Objection submission COM/2019/81 -

Dangers of introducing Cement to the Nucrush quarry site

Attachment A3 - Concrete Plant at Nucrush quarry

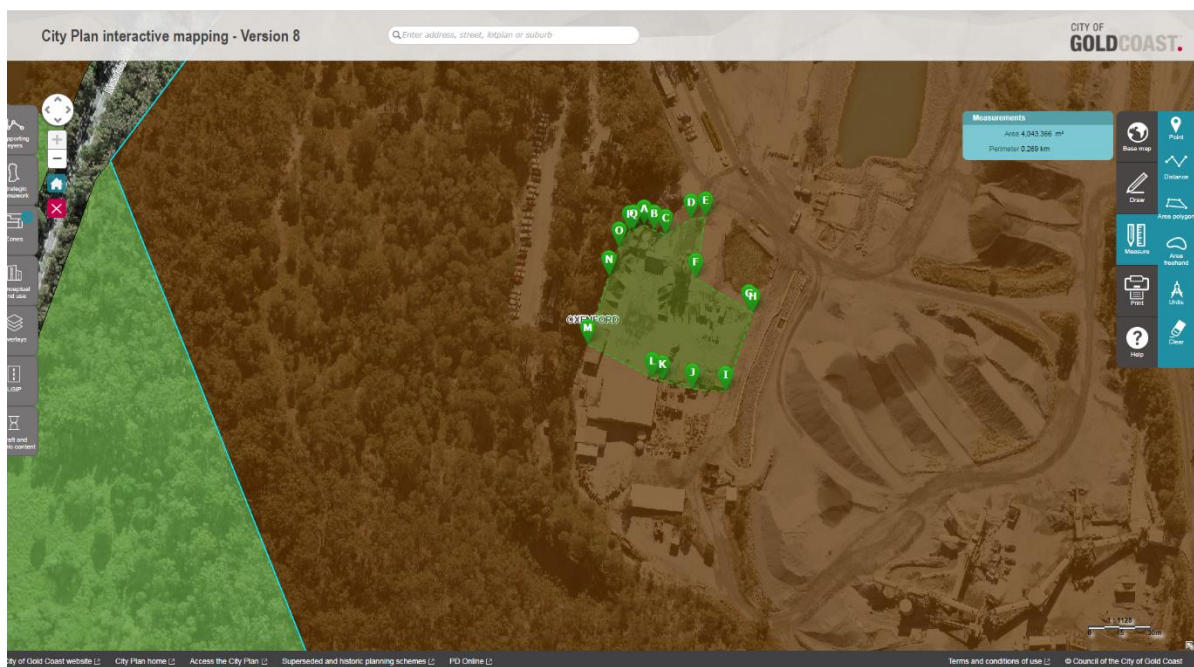
The existing Concrete Production/Batching Facility within the Nucrush quarry is shown in attachment A3. It is roughly four thousand square metres area positioned near the entrance to the quarry as shown in attachment A4.

FIGURE 4.1 – SURVEYED PEAK HOUR TRAFFIC VOLUMES AT THE MAUDSLAND ROAD / SITE ACCESS ROAD INTERSECTION (AUSTRAFFIC – 2014)

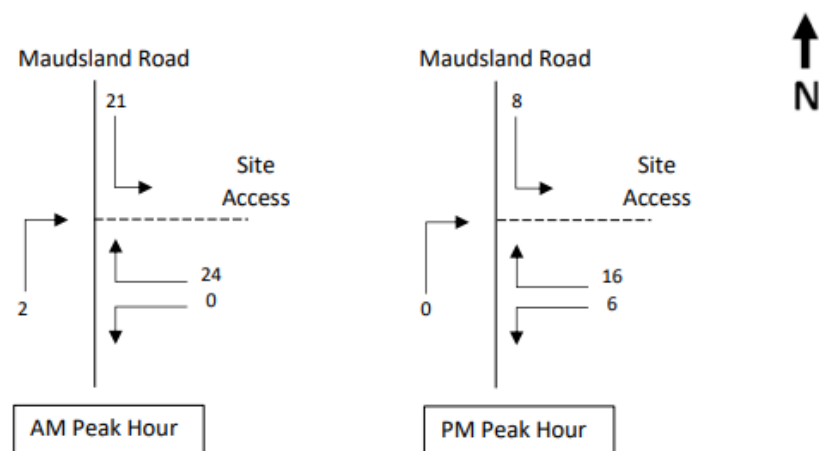
It is noted the delivery vehicles for the concrete production facility are not included in the development application’s Traffic Impact Assessment.

This means there are an estimated 17 loaded trucks every day delivering sand and cement to the site (or 34 truck movements) that appear to be completely unaccounted for in the Traffic Impact Assessment. This is an additional ten percent above the claimed “171 loaded trucks per day” entering and leaving the site (Attachment E1). I believe this is a highly culpable omission and misdirection.
